CORRIGENDUM-I

Tender Notification No.: IIMT/2021-22/IT/HBC/02; Dated 18.05.2021

Notice Inviting Tender for Supply, Installation, Testing and Commissioning of Audio-Visual Materials (Cameras, Speakerphones, Mounting Brackets, Stands Etc.) For Setting up the Hybrid Classrooms in IIM Tiruchirappalli

Corrigendum/Amendments/Extension in the tender document

CEILING PLAN - 80 seater

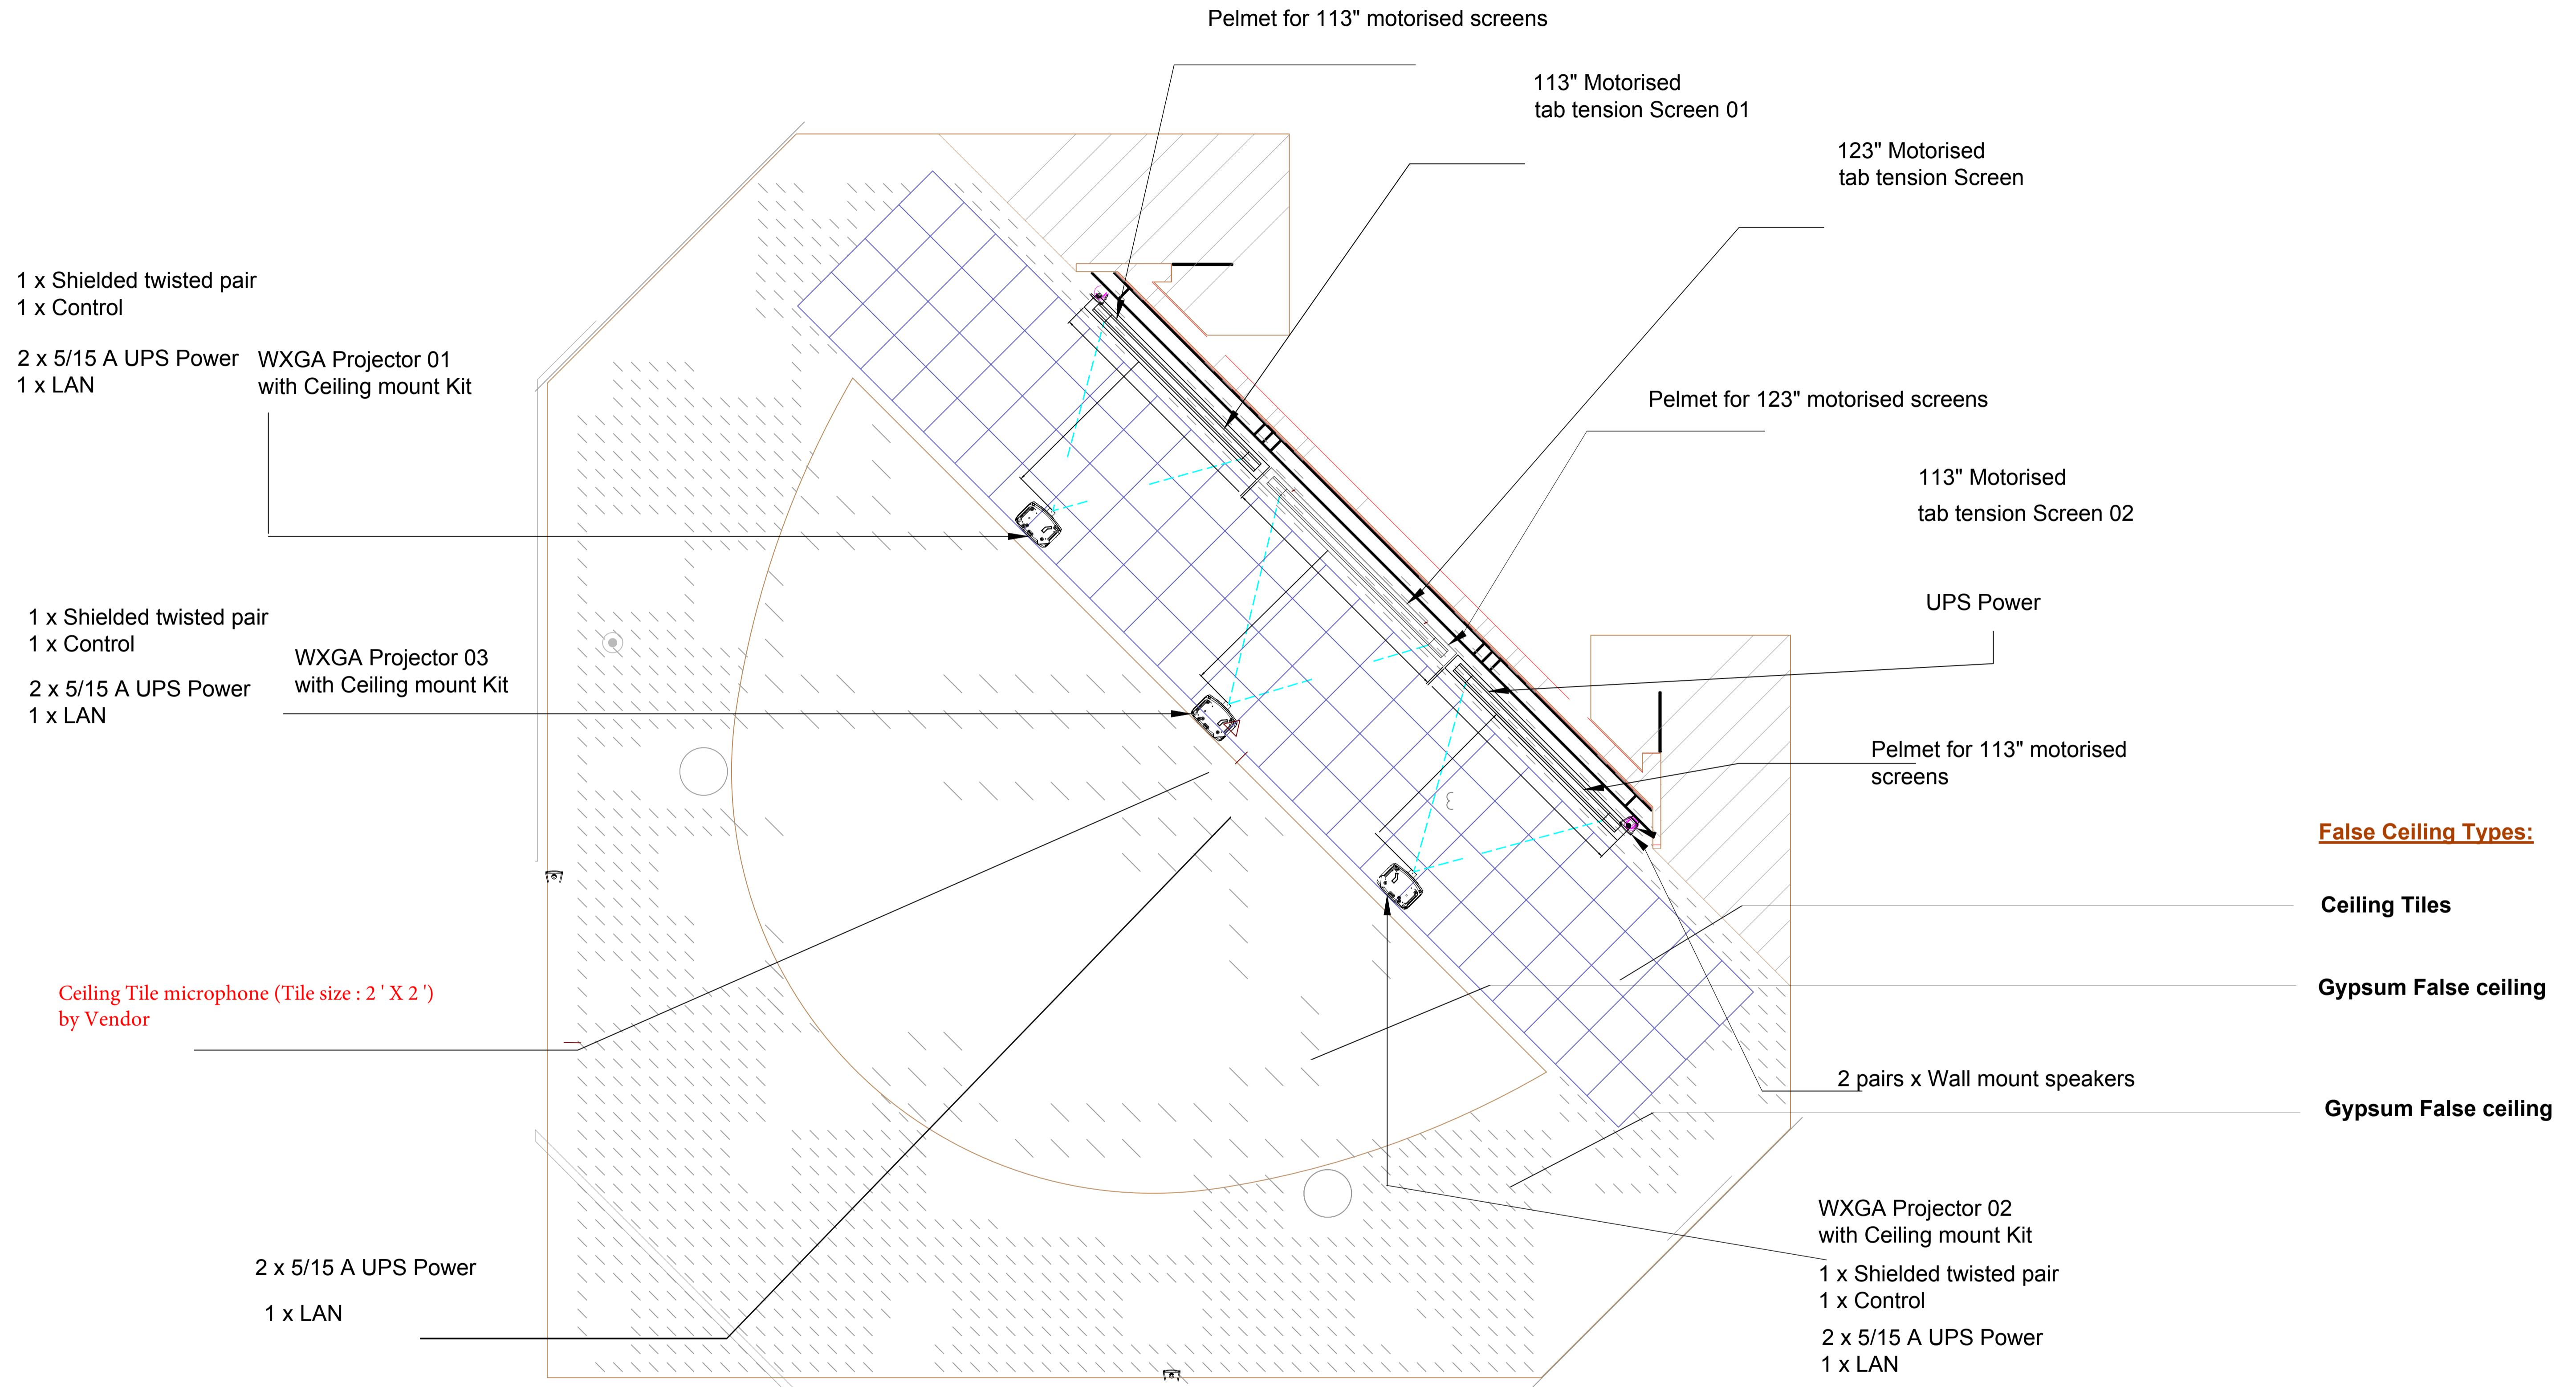
1. The removable tiles (2 X 2') are fixed in front of the screens through which the cable laying can be done.
2. If the installation causes any damage in the gypsum false ceiling, then the same has to be corrected by the vendor.
3. The vendor has to install the ceiling microphone at the required height for maximum performance (voice capture).
4. The conduits are already available on the floor (2.8 Mtrs) and the wall (3.8 Mtrs) through which the cable has to be laid and the conduits are required only at the ceiling (Approximate length : 5 Meters)
5. Please note the following points for reference:

HDMI Cable from Podium wall plate to Faculty table

USB Cable to the Ceiling Microphone (Approximate length : 12 meters)

Camera and mounting stand have to be installed behind this table. Camera should be connected with the computer installed in the student table

Camera and mounting stand have to be installed behind this table. Camera should be connected with the computer installed in the student table (Approximate length : 3 to 5 Meters depending on the positioning of camera)

BLOCK SCHEMATICS OF SOUND REINFORCEMENT & PRESENTATION SYSTEM FOR 80 SEATER (Existing and New)

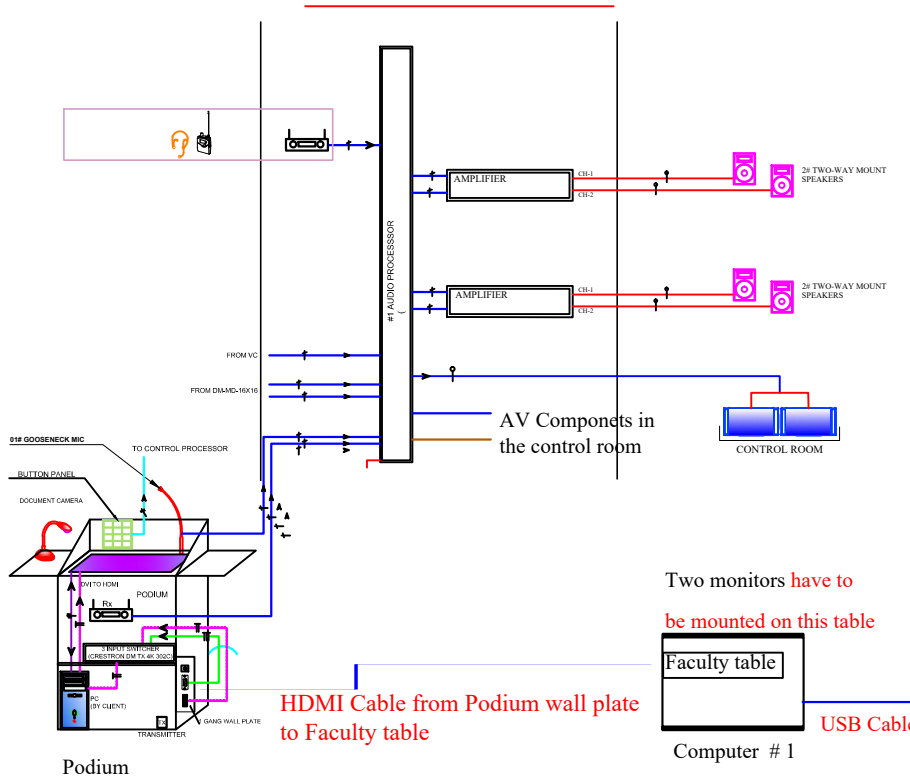
1. Zoom will be connected from both computer #1 and computer # 2 simultaneously .
2. The video input will be feeded from Computer # 2 (Student table- first row) wherein Camera is connected.
3. The audio (speaker and Microphones) have to be feeded from the Computer # 1 (Faculty table).
4. Note the following for reference:

RED: The points mentioned in RED color have to be supplied / installed by the vednor
BLACK: The Components mentioned in BLACK color (includes the details shown inside the top box and inside the podium) are already installed by IIM Trichy.

CEILING PLAN - 50 seater

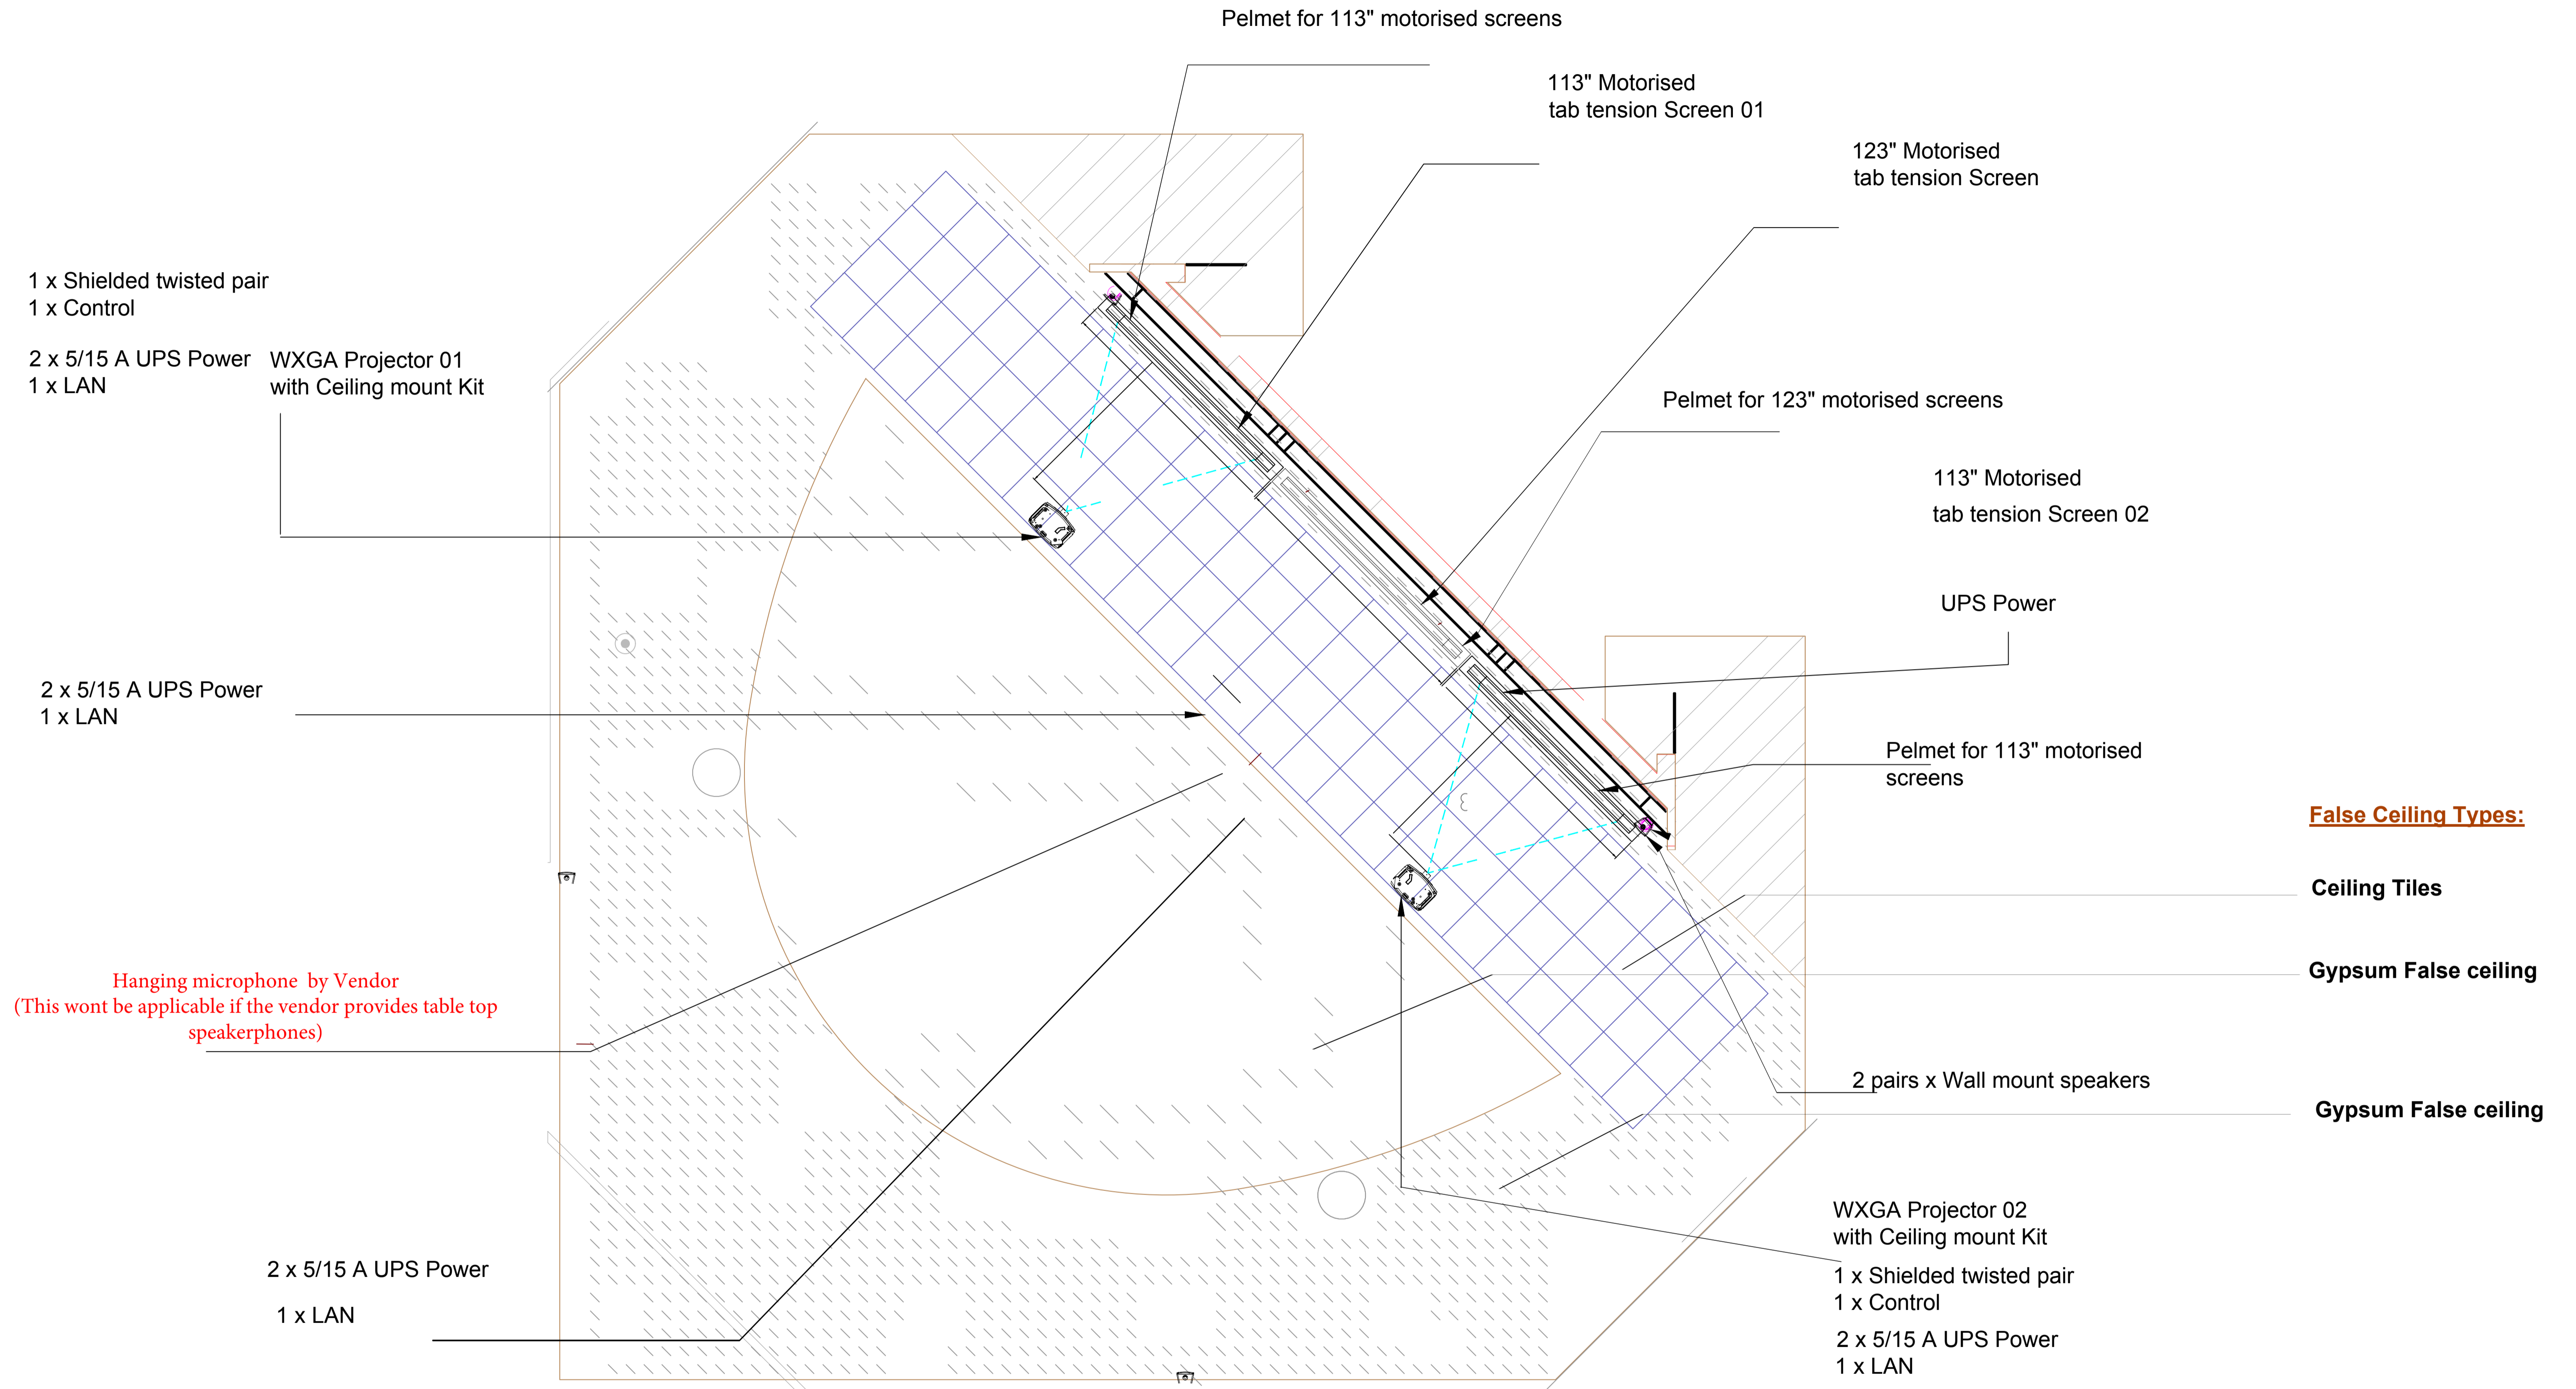
1. The removable tiles (2 X 2') are fixed in front of the screens through which the cable laying can be done.
2. If the installation causes any damage in the gypsum false ceiling, then the same has to be corrected by the vendor.
3. The vendor has to install the hanging microphone at the required height for maximum performance (voice capture). In case of speaker microphones, the same have to be installed on floor stands at suitable position/location for maximum coverage.
4. For the installation of hanging mics, the conduits (1" dia) are already available on the floor (2.8 Mtrs) and the wall (3.8 Mtrs) through which the cables may be laid and the new conduits are required only at the ceiling (Approximate length : 5 Meters)
5. Please note the following points for reference:
